WATCHTOWER EDUCATIONAL CENTER AMENDED SITE PLAN

FINAL ENVIRONMENTAL IMPACT STATEMENT

Final Environmental Impact Statement (FEIS)

Project Location: NYS Route 22, Town of Patterson, Putnam County, New York

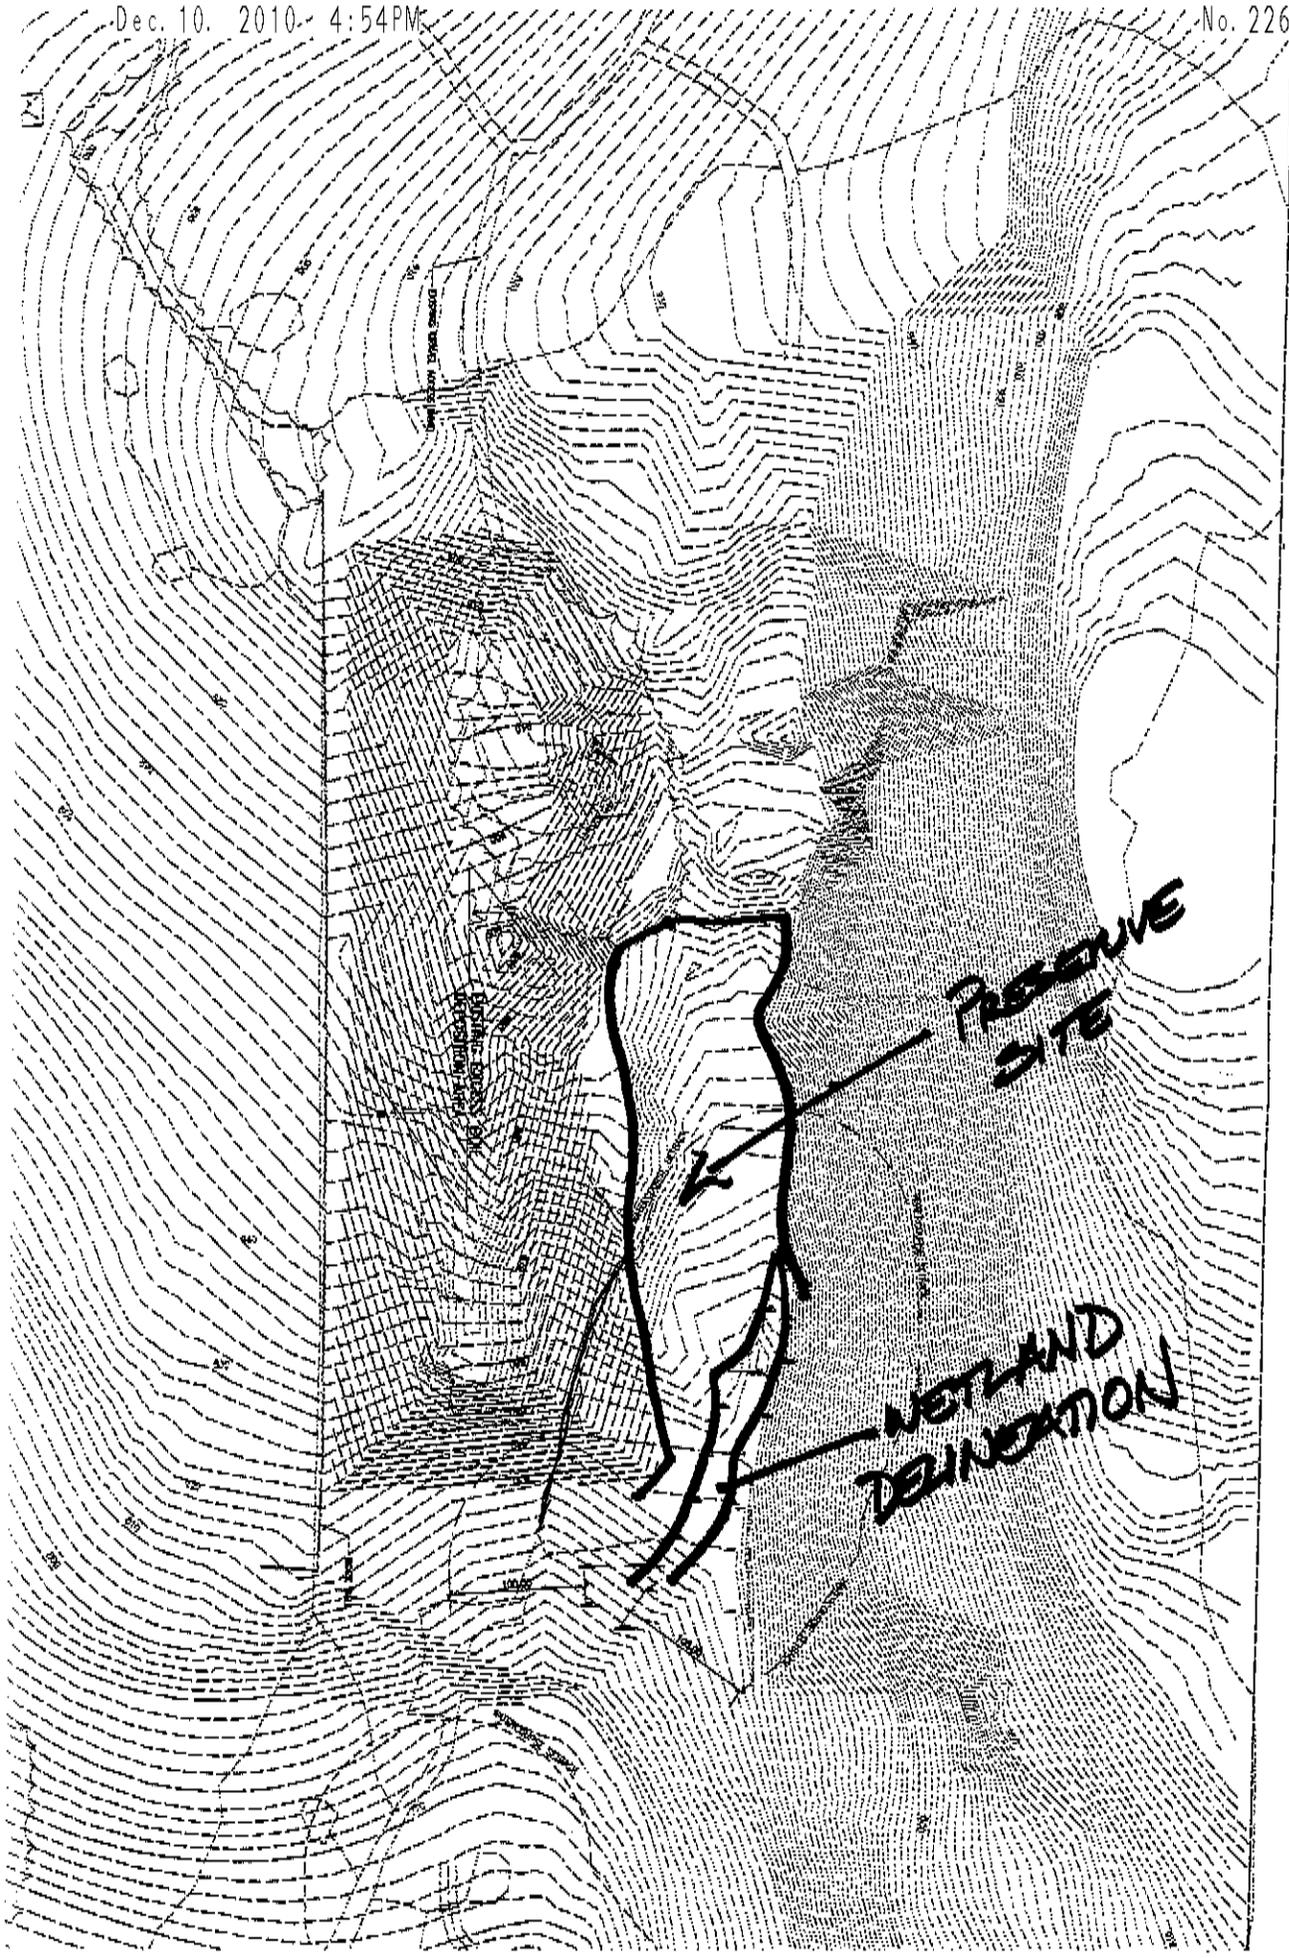
As per our site review on December 3, 2010 with James Nash of AKRF and Richard Eldred, I wish to make the following comments with regard to the wetland delineation and general concept of the project:

1. In general, I agree with the wetland delineation. However, the seeps and seasonal drainage areas to the north of the delineation are part of the headwaters of the stream. Presently the plan is to not enter into this area and it should be maintained as is without any disturbances to preserve it. I have enclosed a map identifying this area of concern. If this area is preserved, I would not oppose the identified disturbance within the wetland buffer as proposed.

2. My concerns about tree removals, view vistas, and site disturbances still remain regarding this location for the excess soil deposition area. The alternate area in the animal pastures in the northwestern section of the tract is in my estimation, far less impacting and more practical. Although a bridge is needed to cross the stream, I feel that you will eventually need improved access to this area in the not too distant future. Why not do it now?
